**Department of Planning and Environment**
Issued under the Environmental Planning and Assessment Act 1979
Approved Section 4.55 (1A) Modification Application
No: SSD 10437 MOD 1 Granted on 16 August 2022
Signed: AW Sheet No: 1 of 21

Project
WATERLOO METRO QUARTER DEVELOPMENT

Sheet title
General Arrangement Plan
Ground Floor Plan

Sheet title
General Arrangement Plan
Level 23 Plan

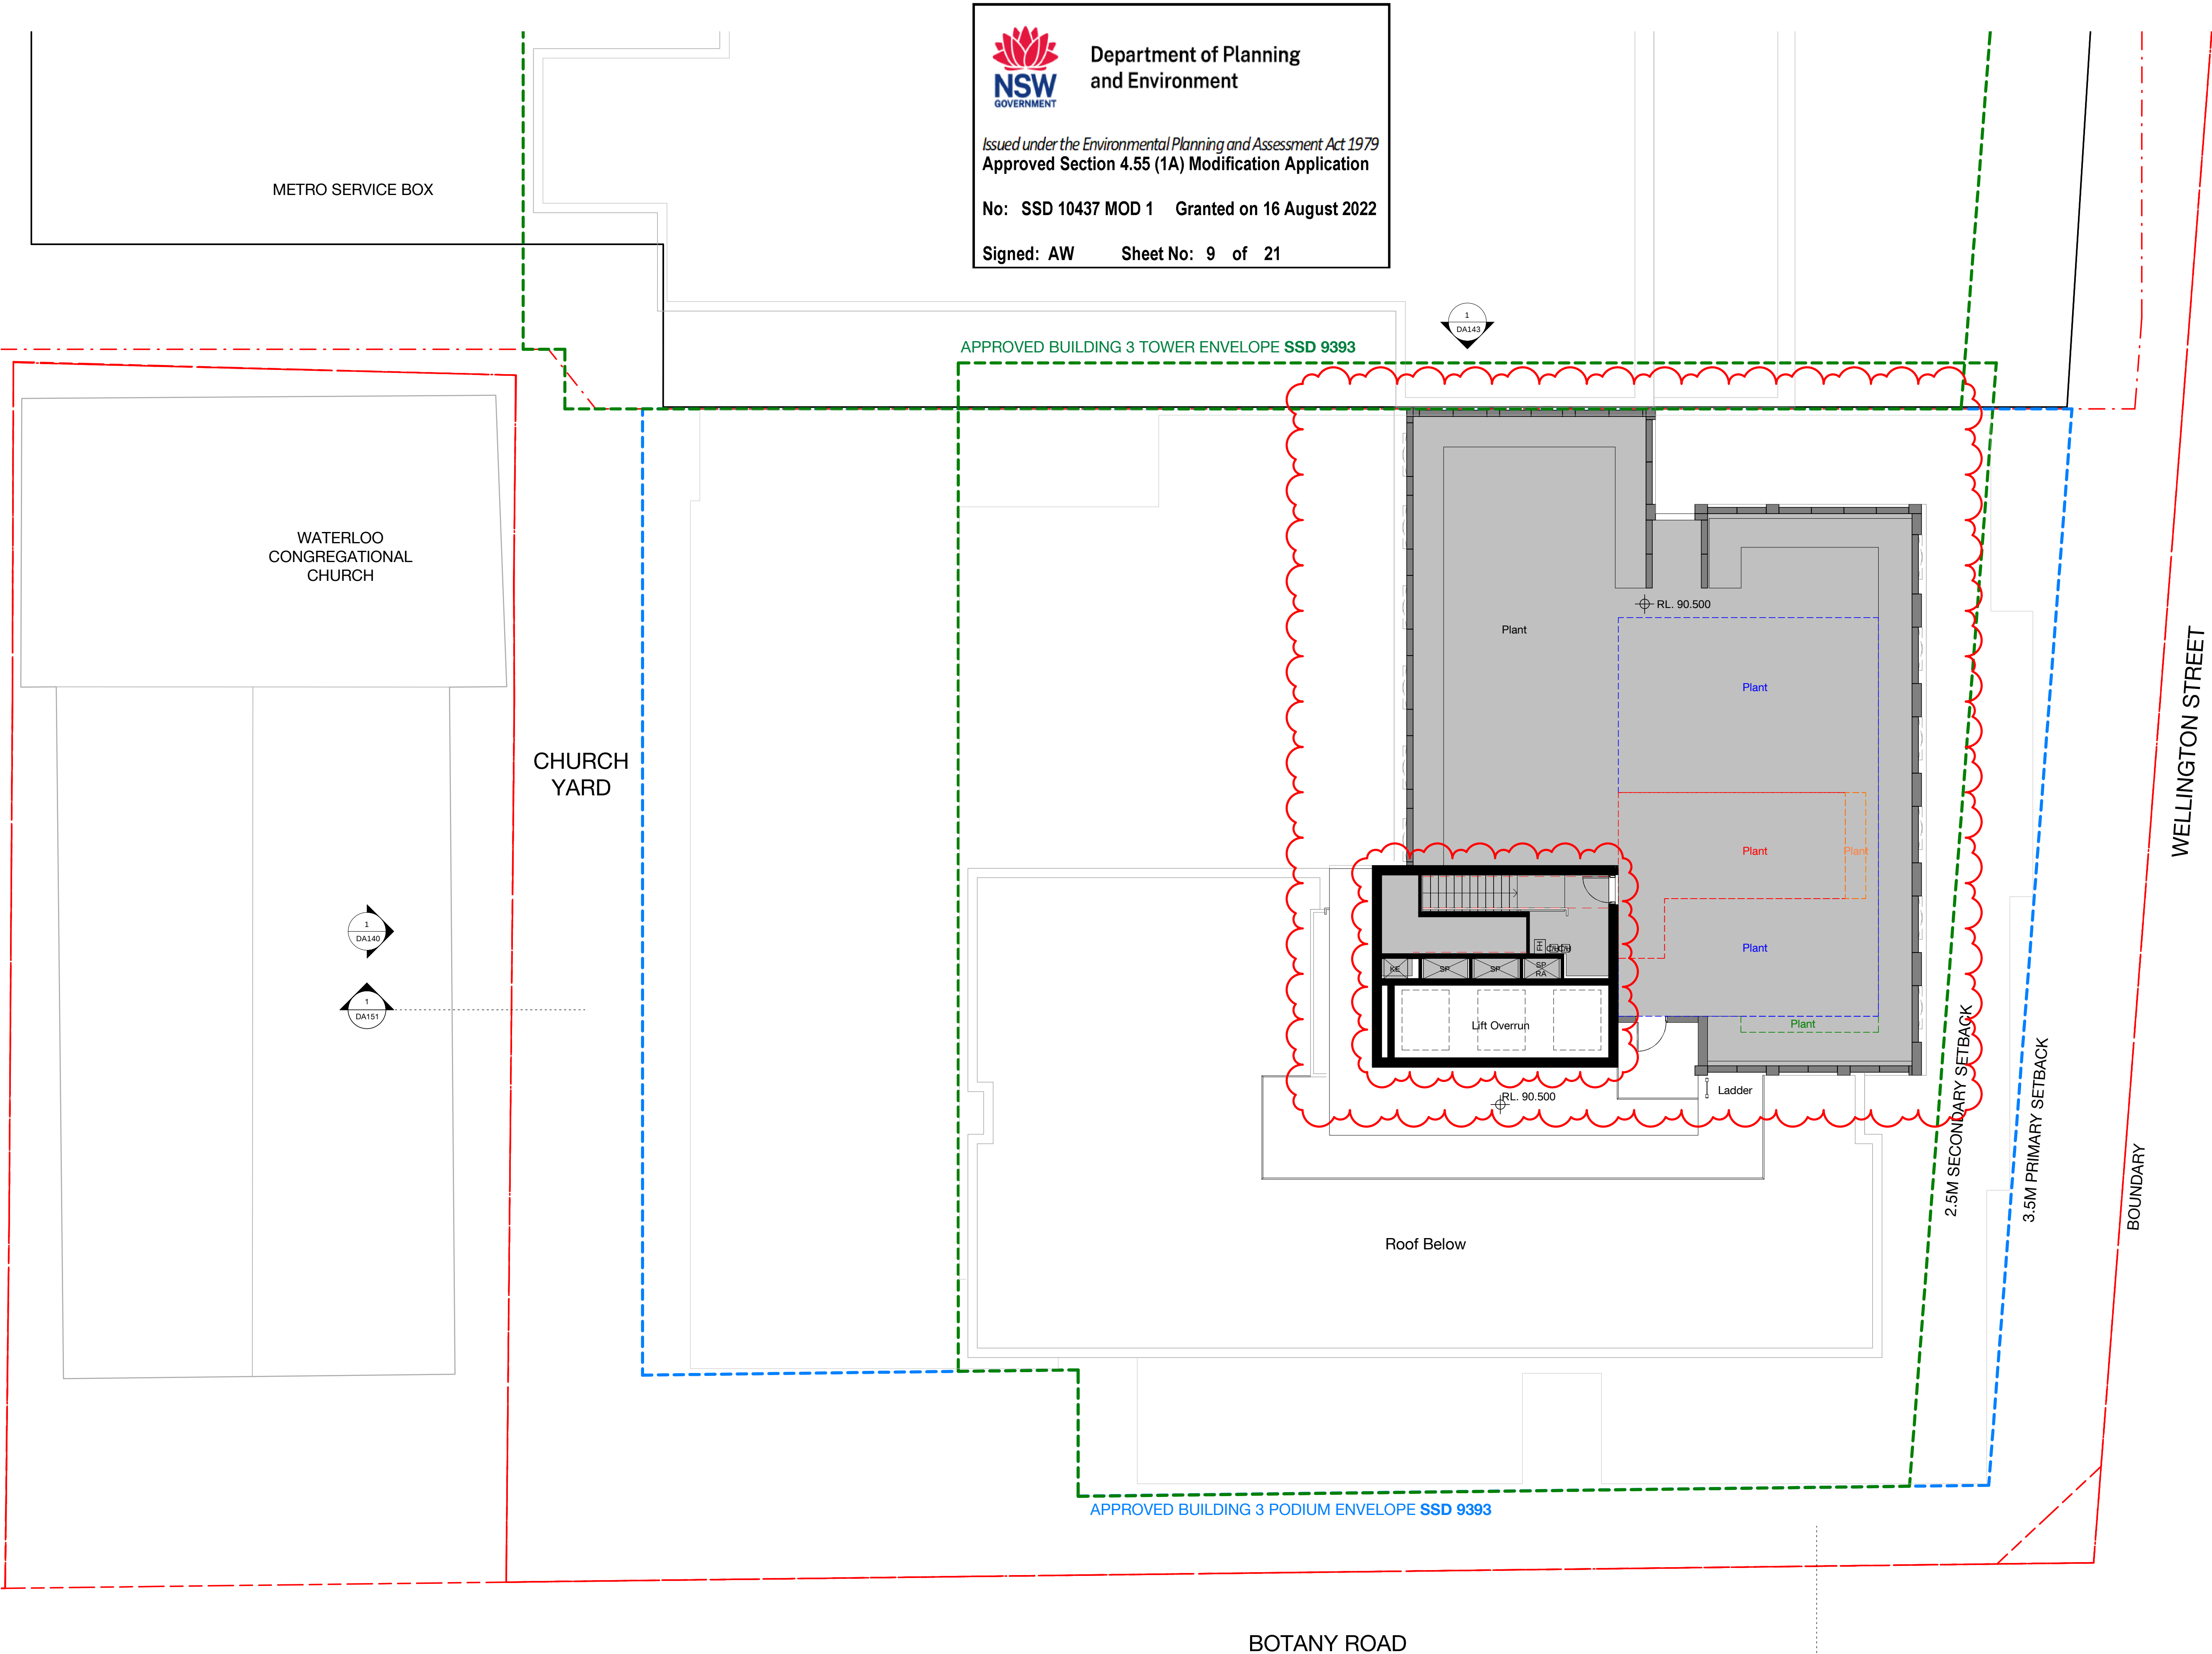
Modification Changes
- Student Accommodation - reconfiguration to the core and services

General Arrangement Plan
Level 24 (Plant) Plan

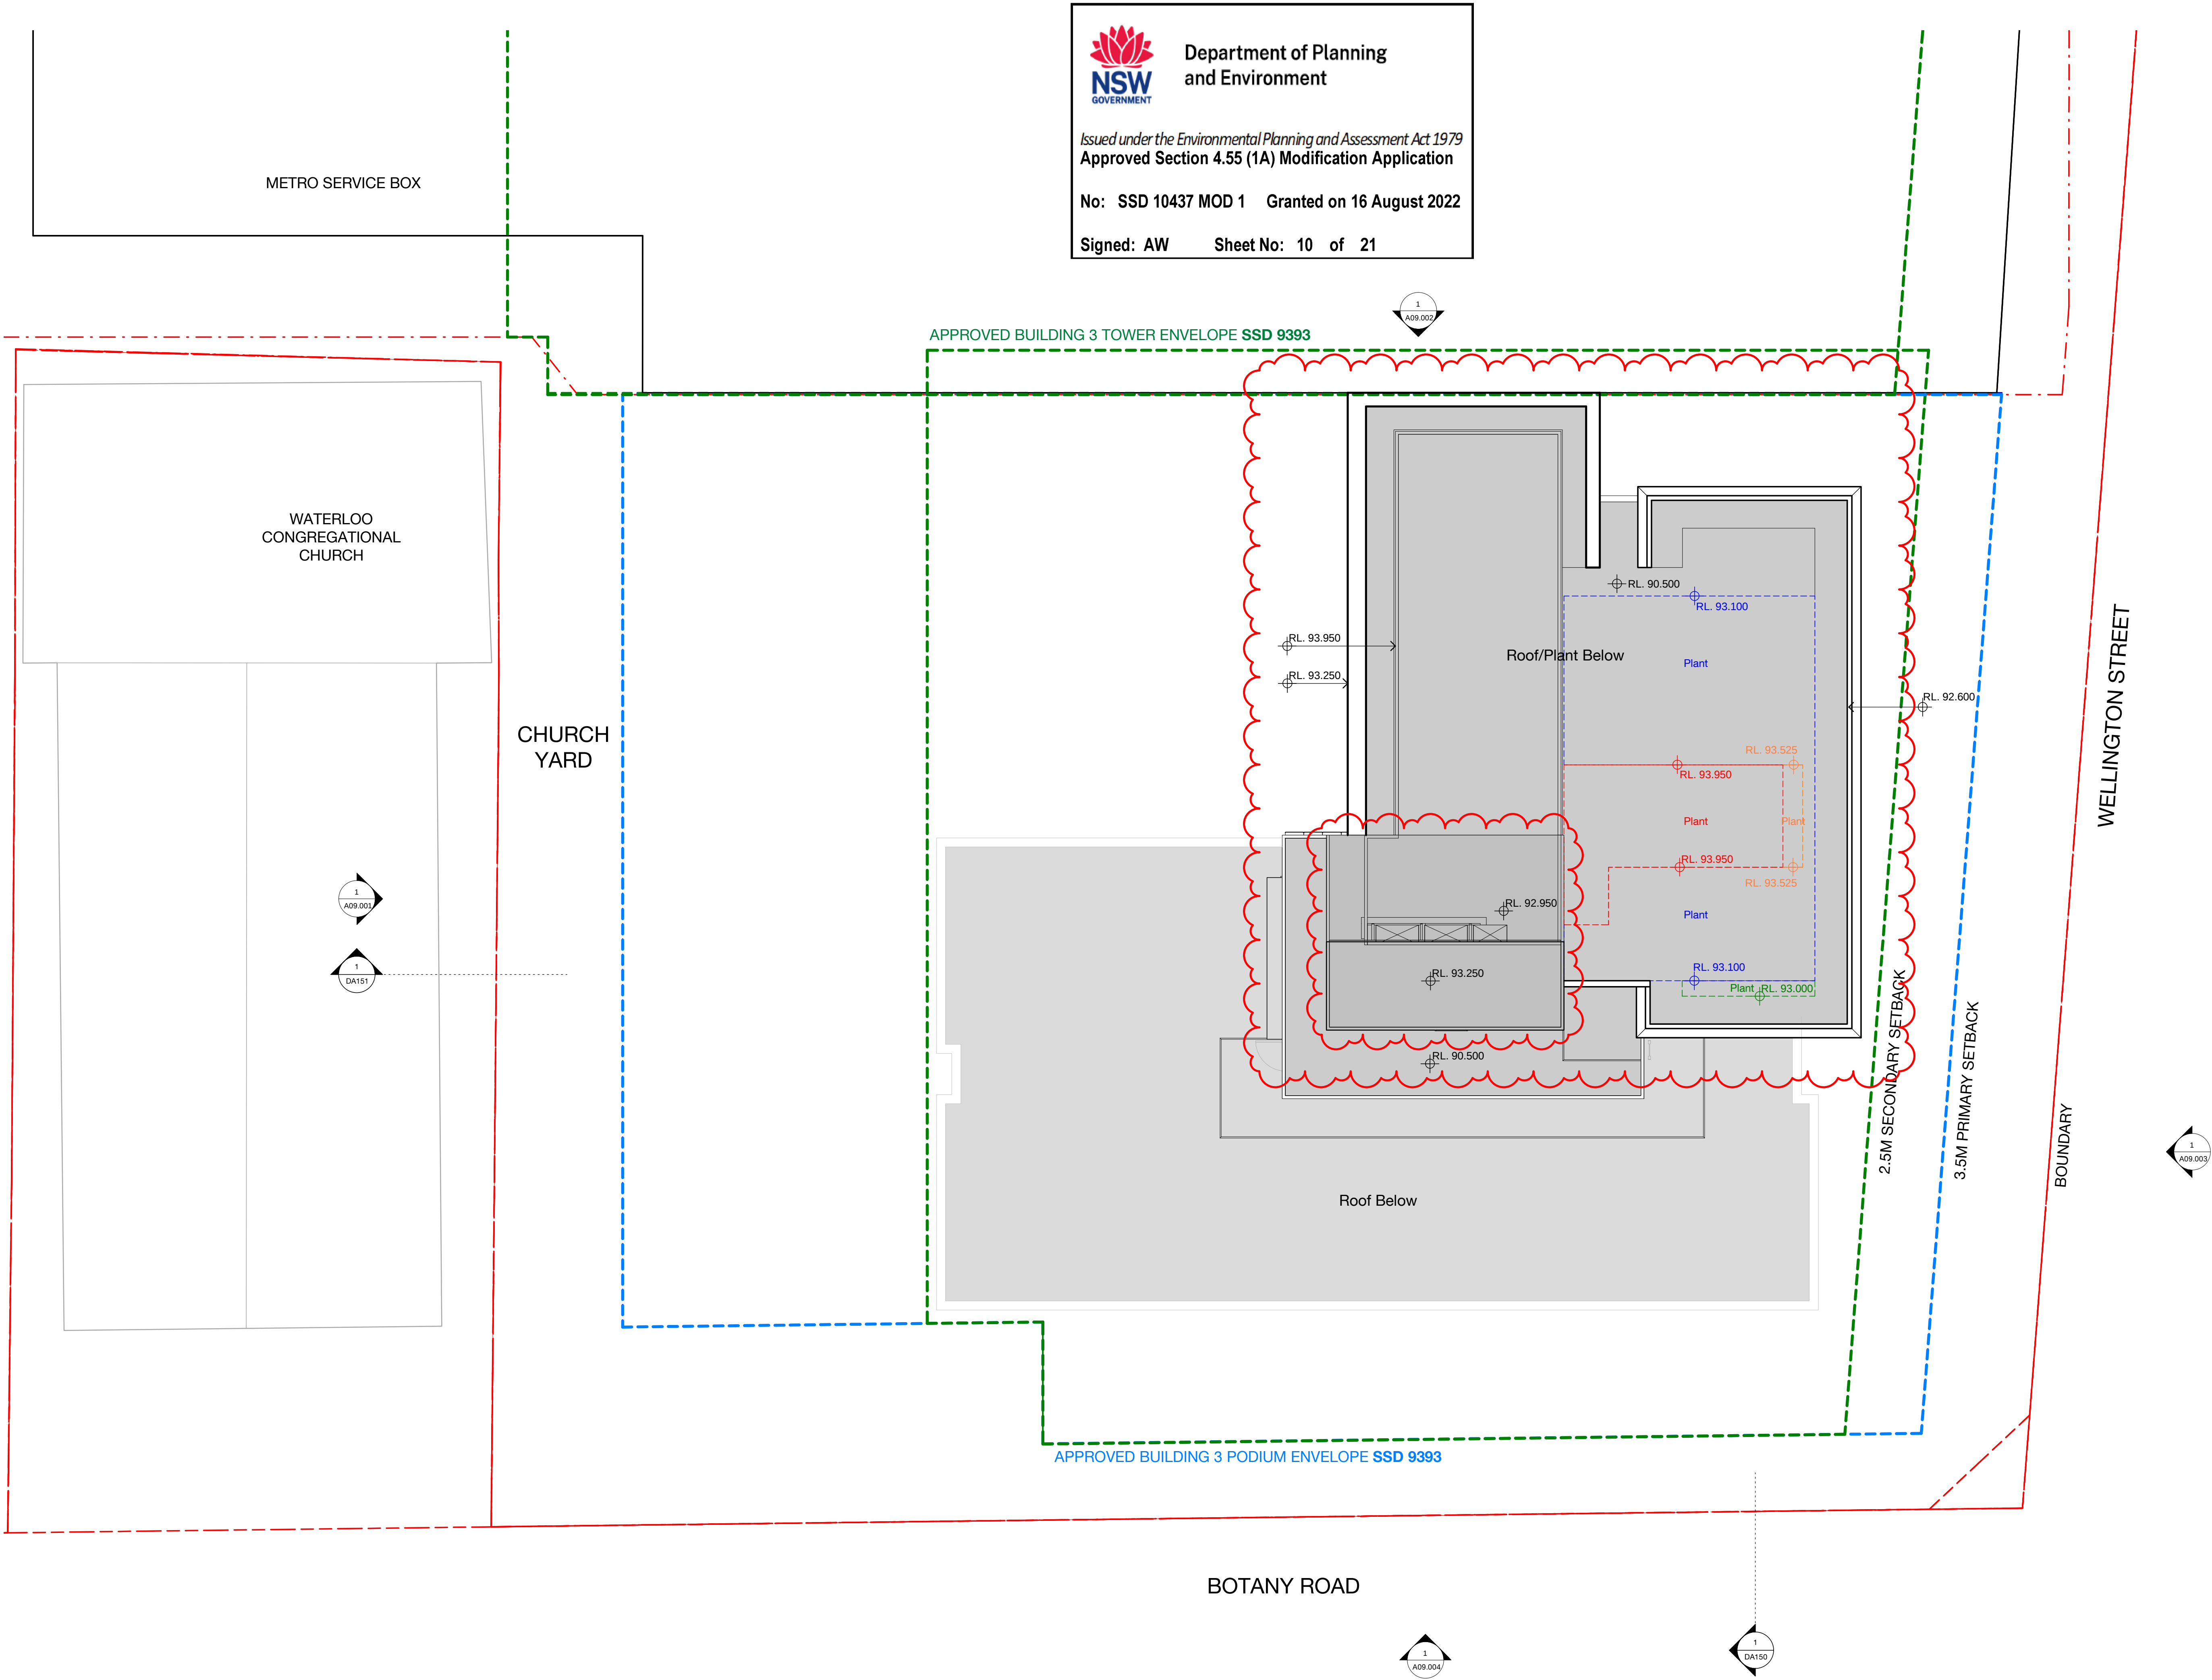
- Modification Changes
- Student Accommodation - reconfiguration to the core and services
 - Roof plant zone

Sheet title
General Arrangement Plan
Roof Plan

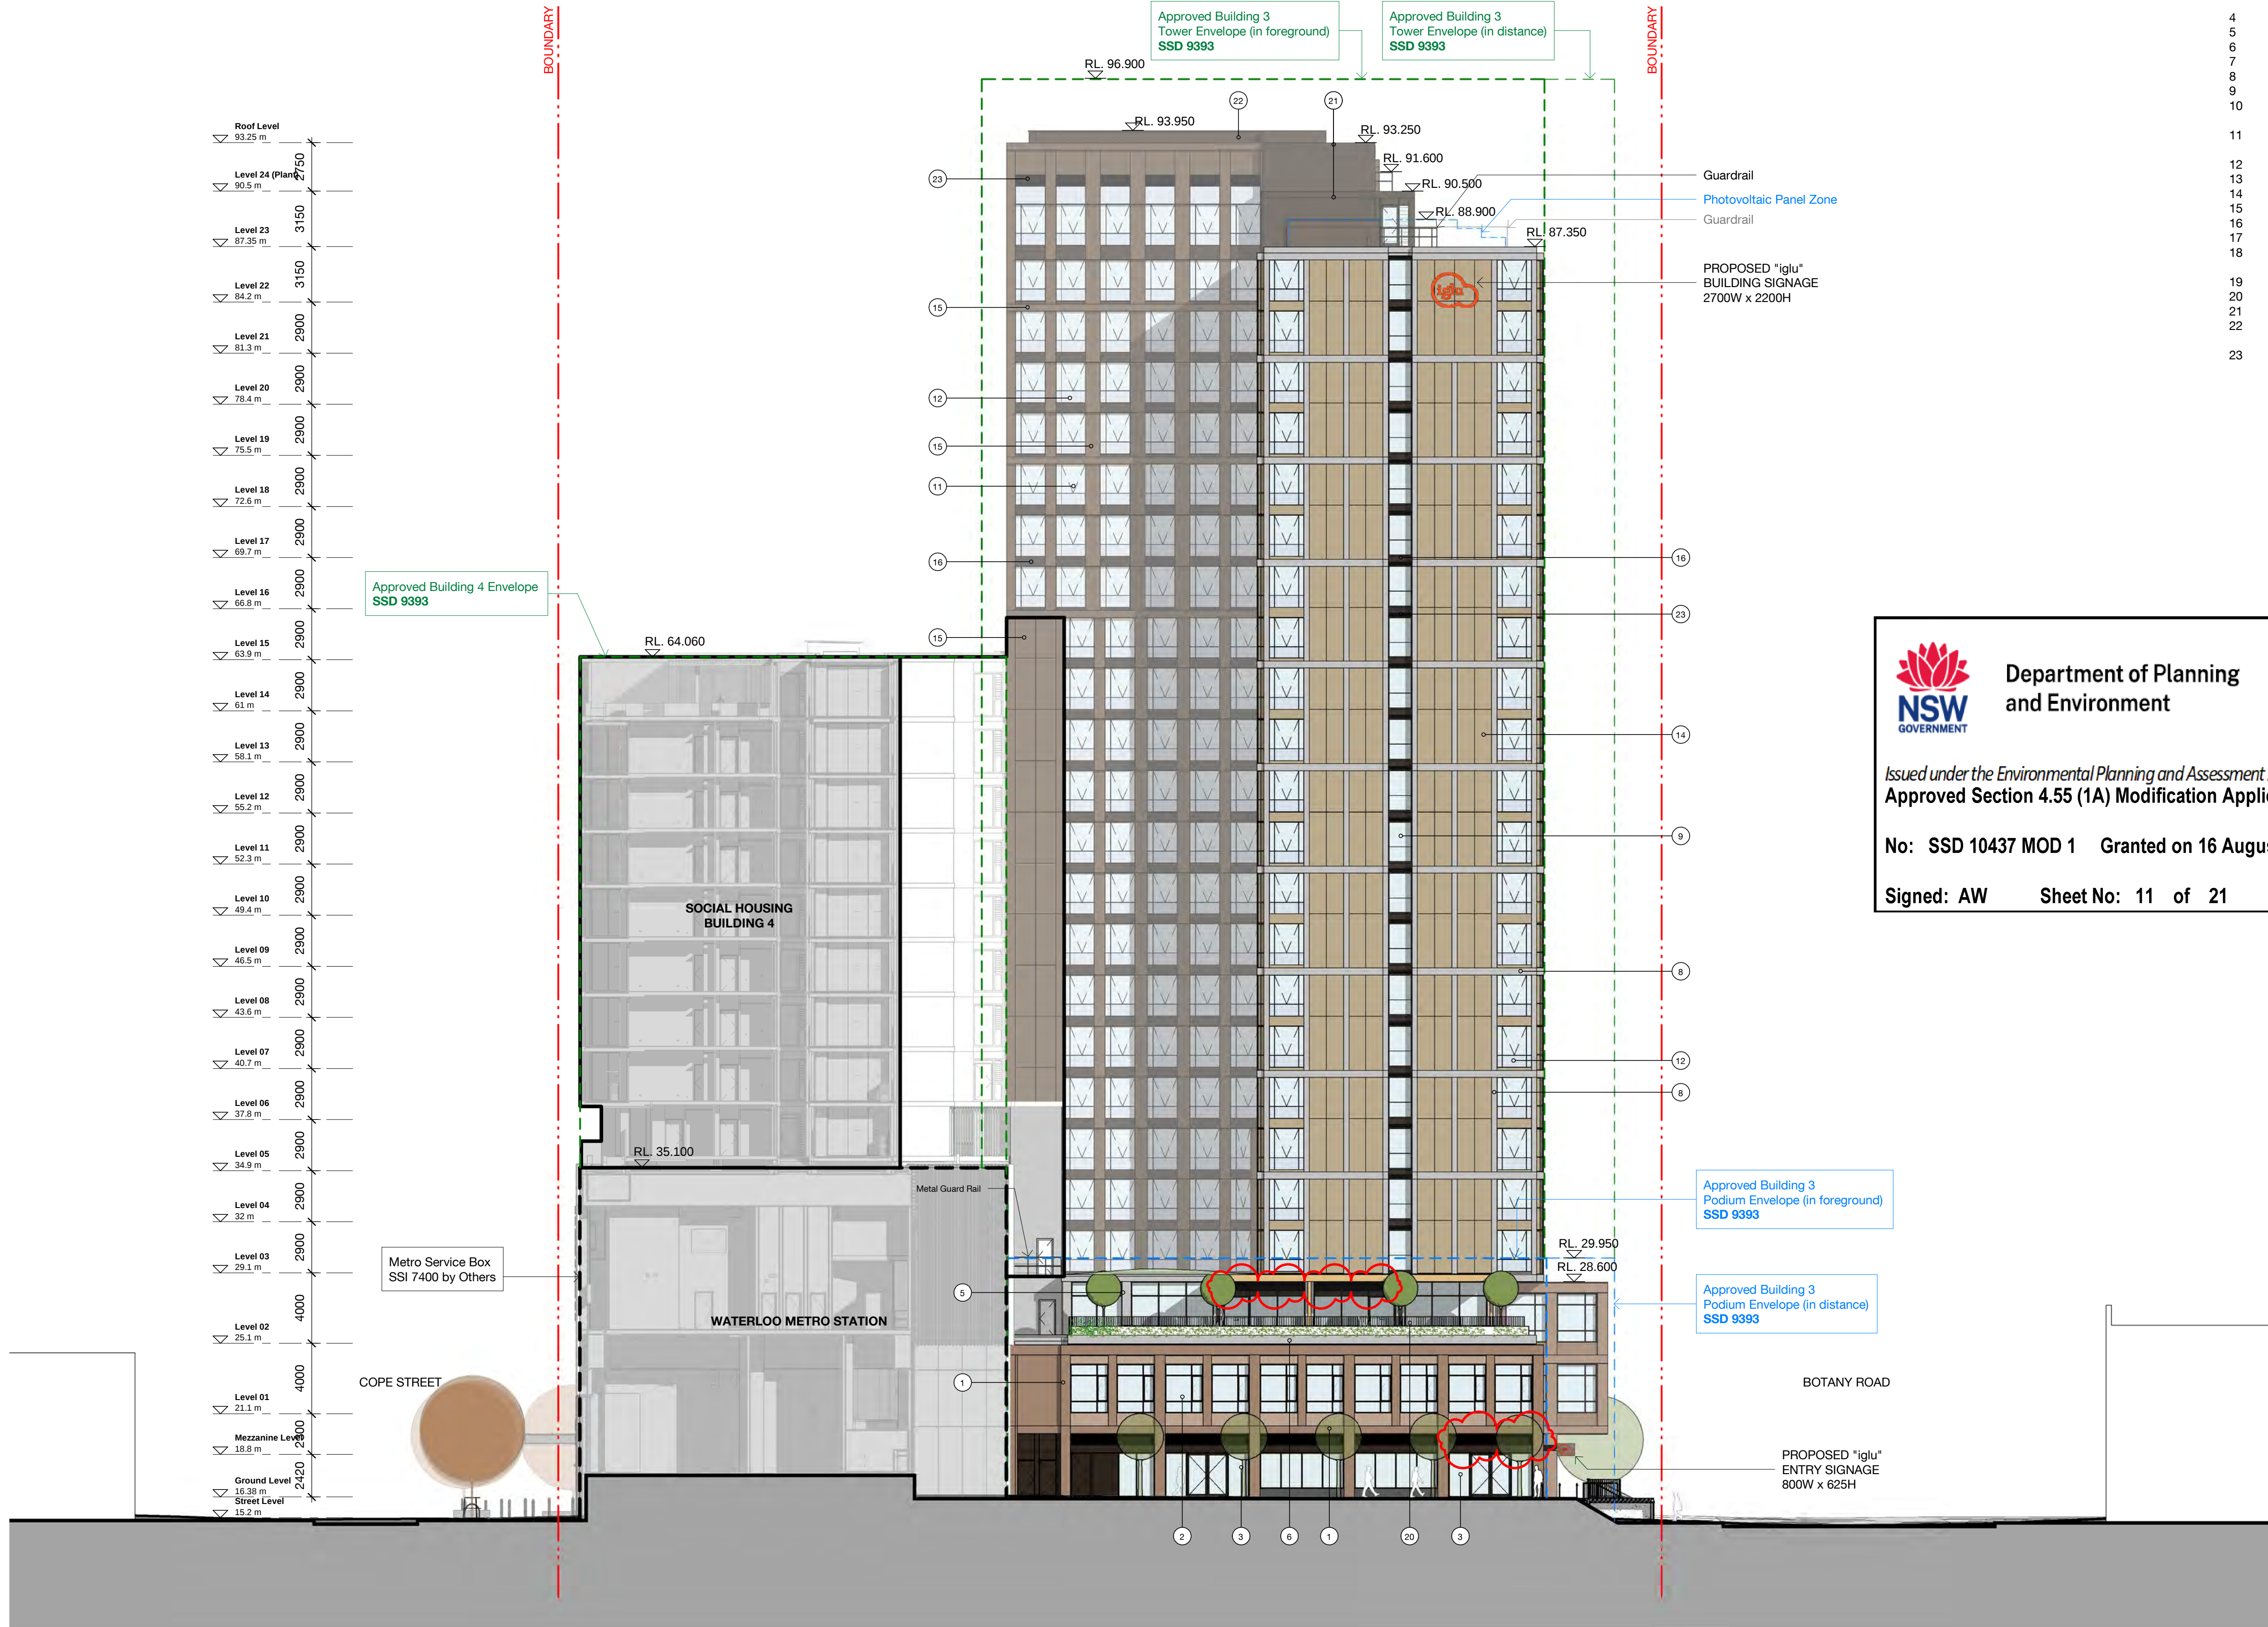
- Modification Changes
- Student Accommodation - reconfiguration to the core and services
 - Roof plant zone
